**SHOP DRAWING REVIEW**  
 REVIEW IS ONLY FOR GENERAL CONFORMANCE WITH DESIGN CONCEPT

B.U.R. CONSTRUCTION  
 VT ROUTE 14 (MINOR ARTERIAL)  
 BARRE, VT

BOX CULVERT LAYOUT AND DETAILS

Drawing No. C21980-LO1A

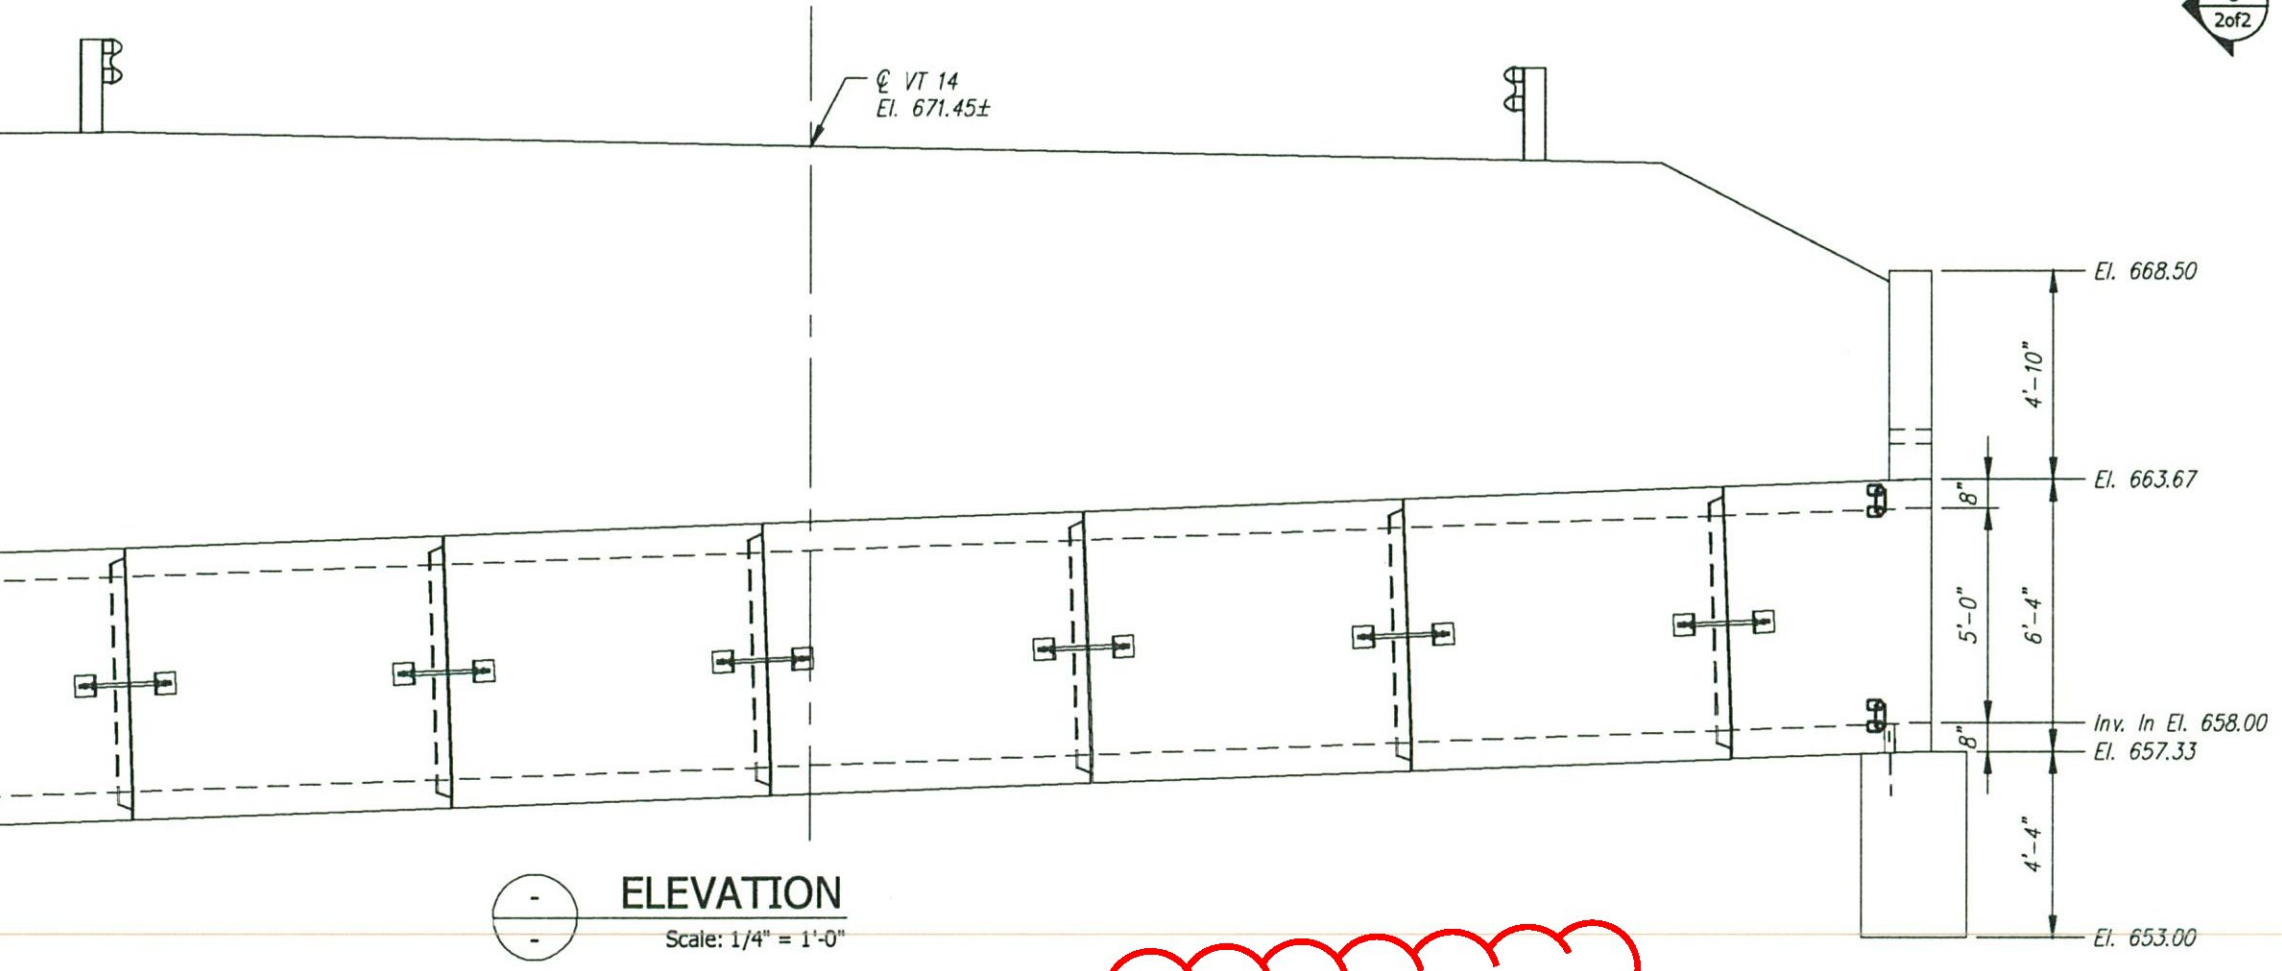
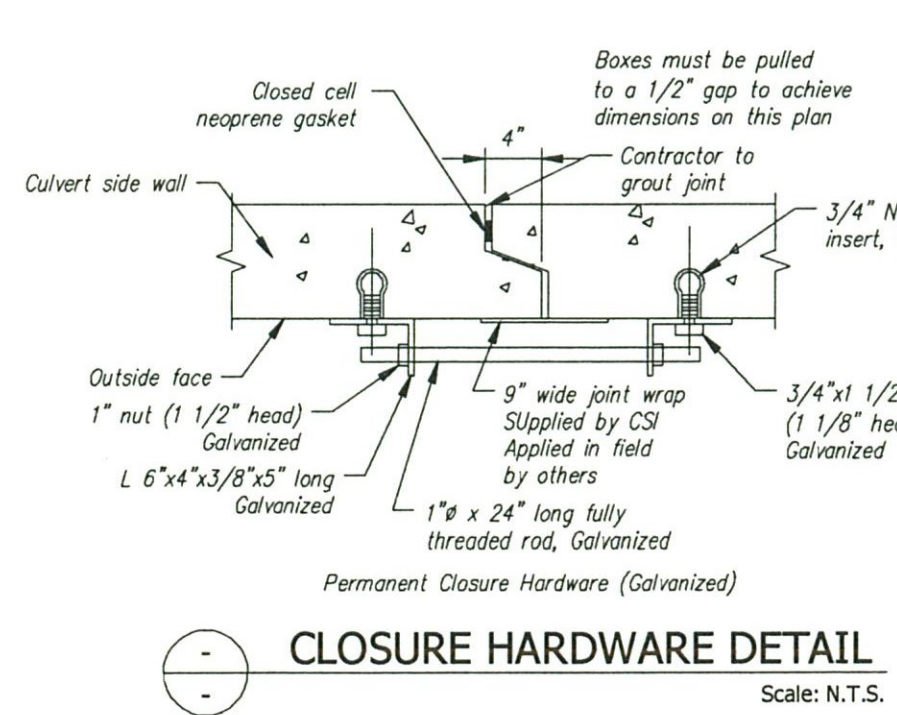
PE Stamp please
